SHASTA COMMUNITY HEALTH CENTER
1035 PLACER STREET

LOCATION: REDDING, CA

DATE: 11 AUG. 2010

SOLAR PANEL ANCHORAGE
NO SCALE

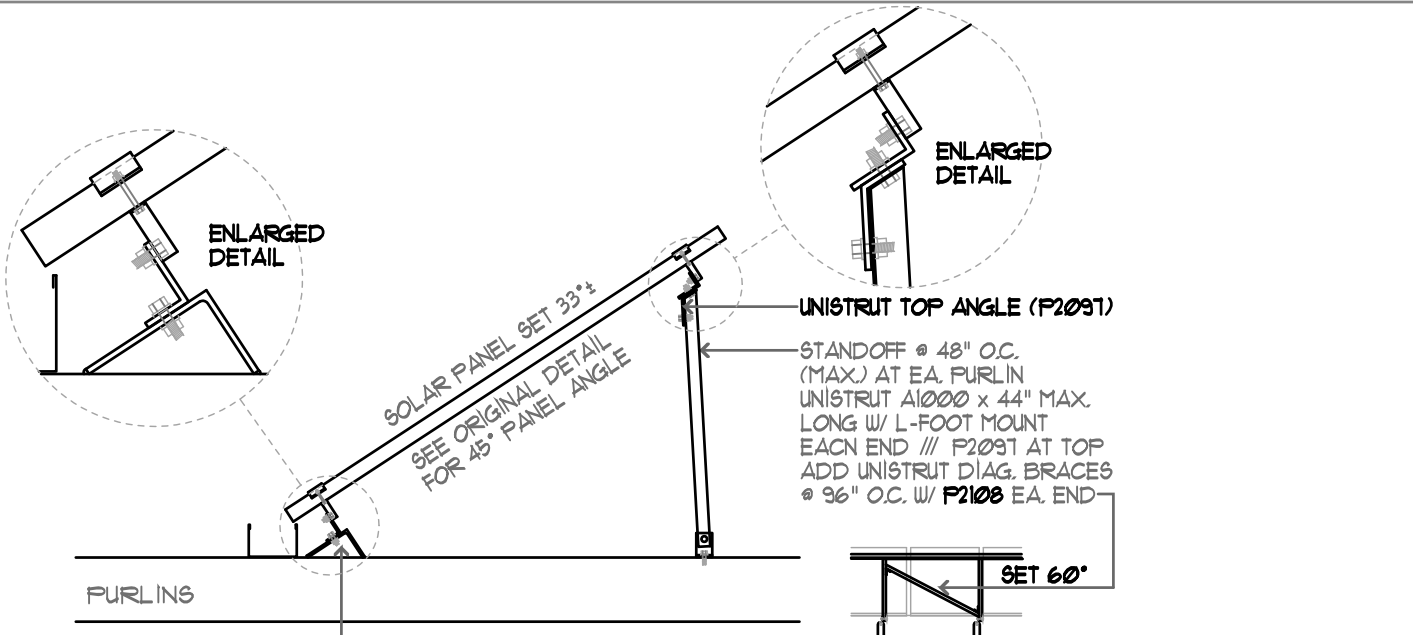
CONDITION W/ 6"x4"x1/4"x3" LONG STEEL ANGLE AS SHOWN FOR 33° ±
SIMILAR CONDITIONS ARE SHOWN BELOW

INSTALL L FOOT PRIOR TO WELD ANGLE TO PURLIN AT LOWER ANGLES

PANEL BTM SHALL EXTEND OVER GUTTER, TYP.

PROVIDE SHALLOW TYPE NUT AT TIGHT SPACE, VERIFY DEPTH

• 6"x3 1/2"x1/4"x3" LONG STEEL ANGLE = 29.5° ±
	• 6"x3"x1/4"x3" LONG STEEL ANGLE = 25.6° ±
	• 6"x2 1/2"x1/4"x3" LONG STEEL ANGLE = 21.3° ±
	• 6"x2"x1/4"x3" LONG STEEL ANGLE = 16.9° ±
	• 6"x1 1/2"x1/4"x3" LONG STEEL ANGLE = 12.3° ±

• 6"x1"x1/4"x3" LONG STEEL ANGLE = 7.5° ±
	• 6"x3/4"x1/4"x3" LONG STEEL ANGLE = 5° ±

MODIFY F2108 FIELD VERIFY ANGLE
MODIFY F2108 FIELD VERIFY ANGLE
